technical bulletin

No TB-0004B Revision Date 10/06/2020

Rattler Bar Dispenser Valve Retainer Clip

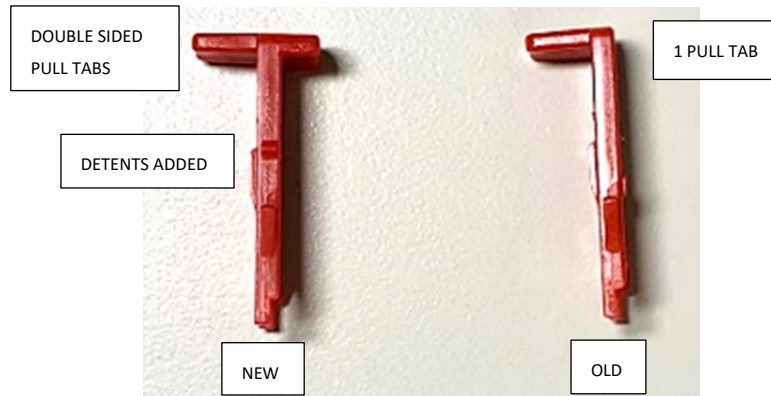
Part Number 265-0759 Retainer, Clip ¼" Fitting has been revised. This revision was implemented as a running change for all Rattler Bar Dispensers and service parts. There are two distinguishing cosmetic features resulting from this change. An extra pull tab on top and a detent on both sides were added, see photo below.

Remove old retainer by twisting side to side while pulling upwards.
Note: Pliers may be used to remove retainer, however, be cautious not to damage valve body.

Install new retainer clip with the larger tab facing towards the outside of the valve
